**REMEDIAL INVESTIGATION AND
FEASIBILITY STUDY WORK PLAN
CORNELL-DUBILIER ELECTRONICS SUPERFUND SITE
OPERABLE UNIT NO. 3 (OU-3) GROUNDWATER**

**February 2006
DANA.001.001.02.0B**

Figure 2-1
Site Location Map
OU-3 RI/FS Work Plan

Figure 2
PCB's in Shallow Bedrock Groundwater

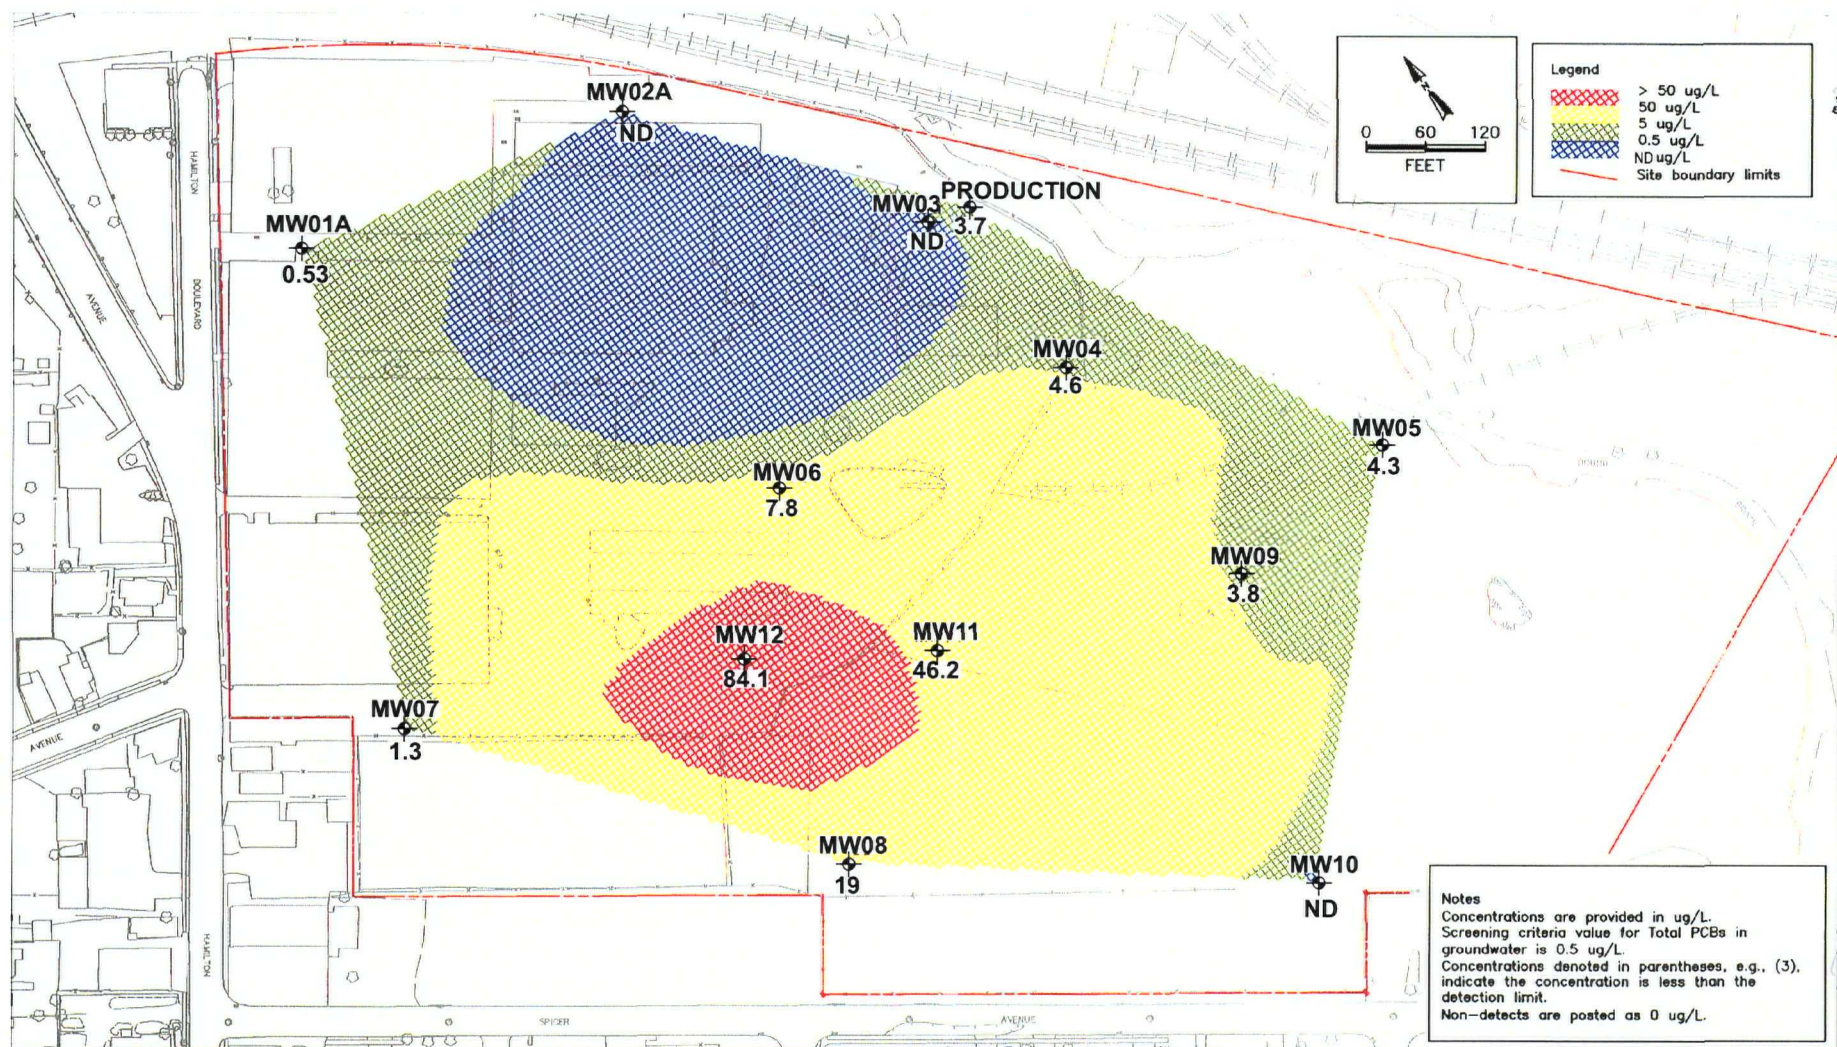
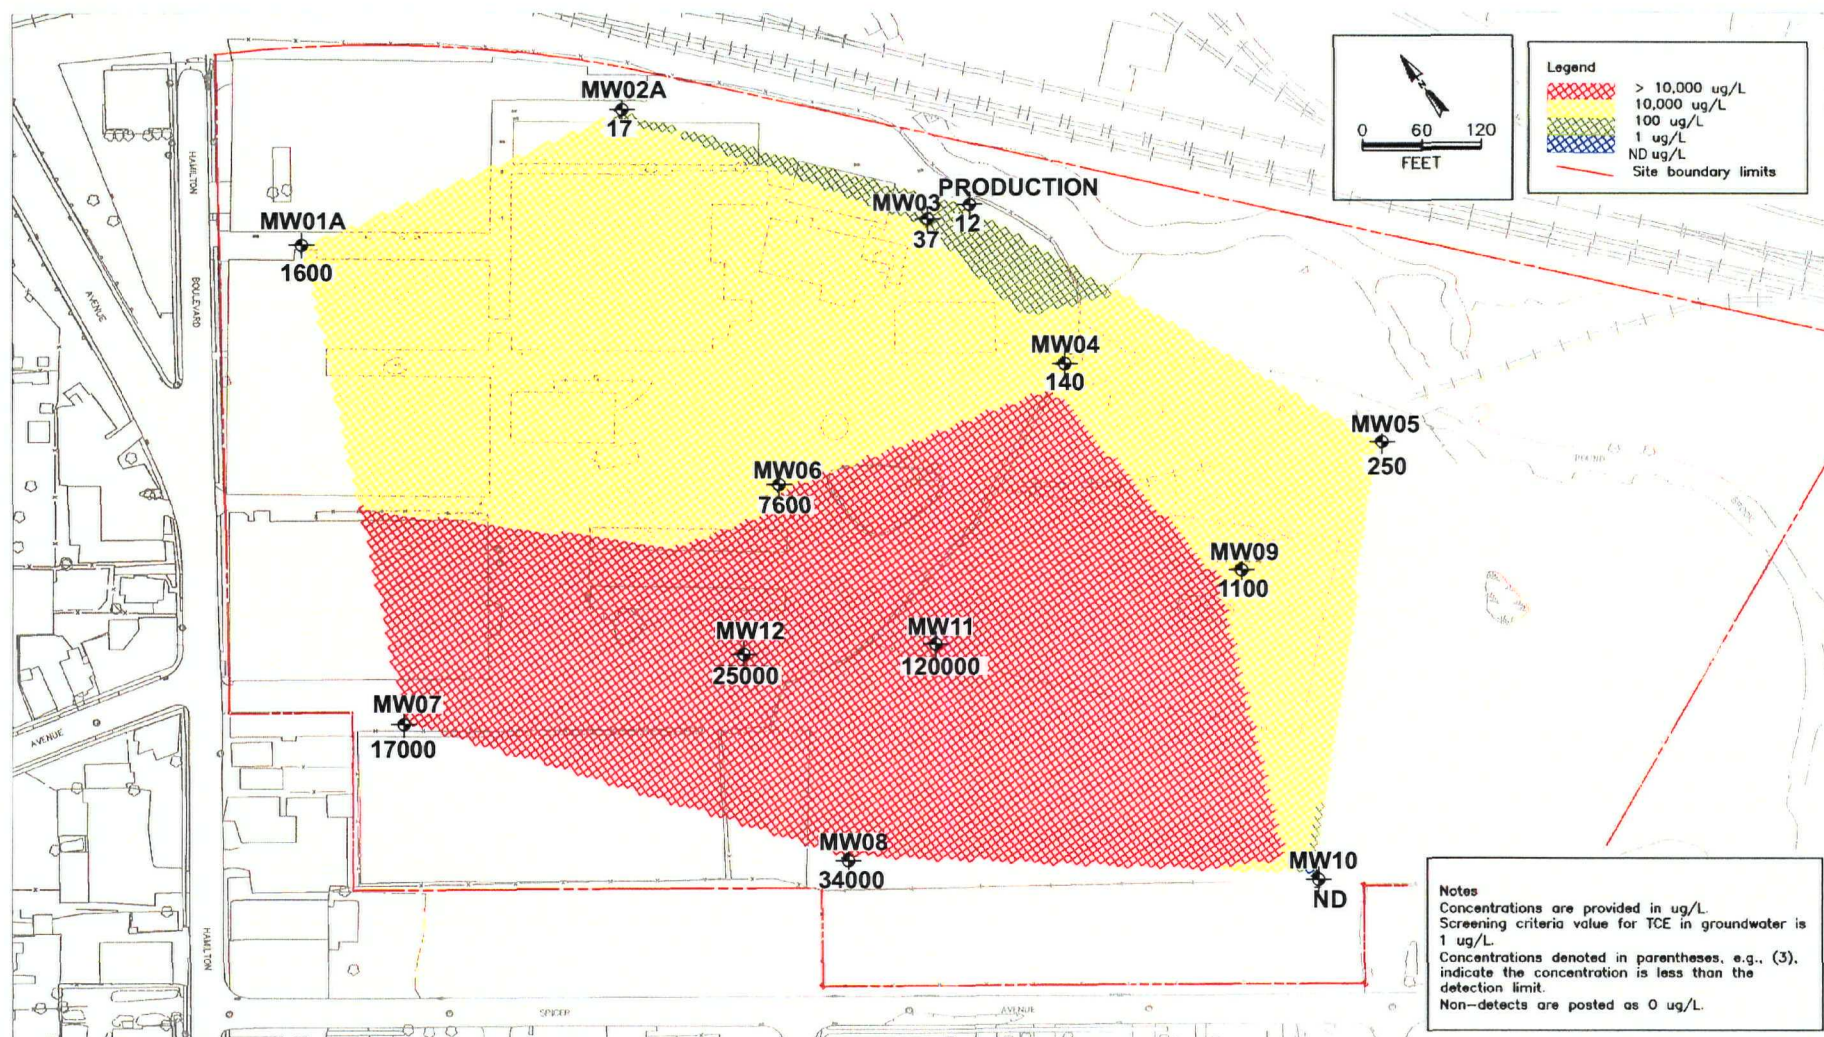
Figures 2 and 3 – the figures contain a contour for concentrations of “0 ug/L”. Please revise this to more accurately reflect the concentrations that are being represented (i.e. non-detect).

Figure 4
TCE Levels in Bedrock Groundwater

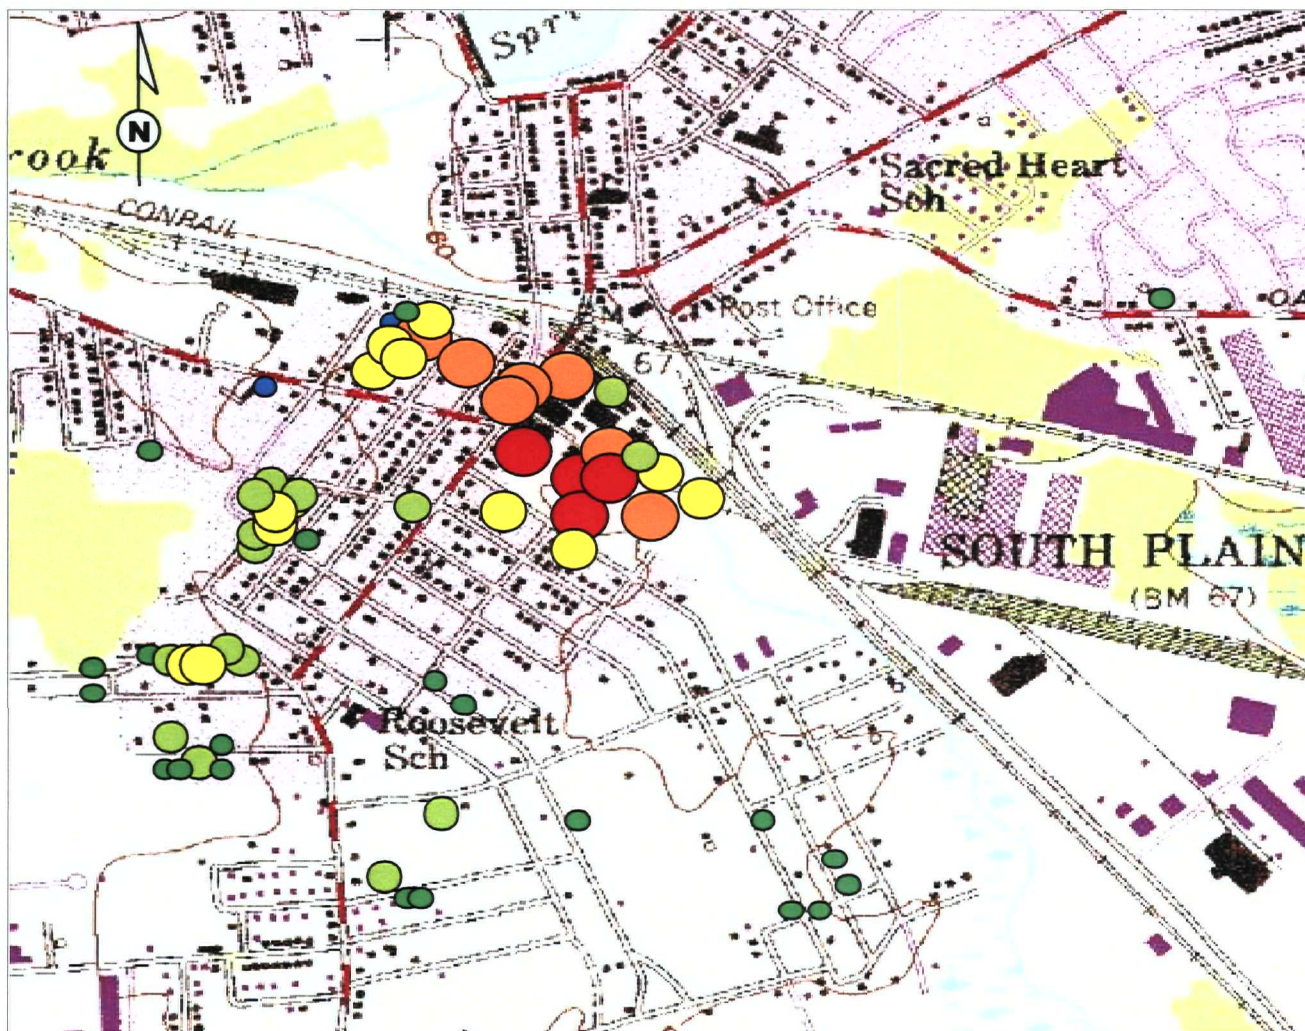
Figure 4 – The icons used to identify TCE concentrations are virtually indistinguishable. Please revise the figure to include icons that can easily be distinguished so that TCE concentrations can be more easily identified.
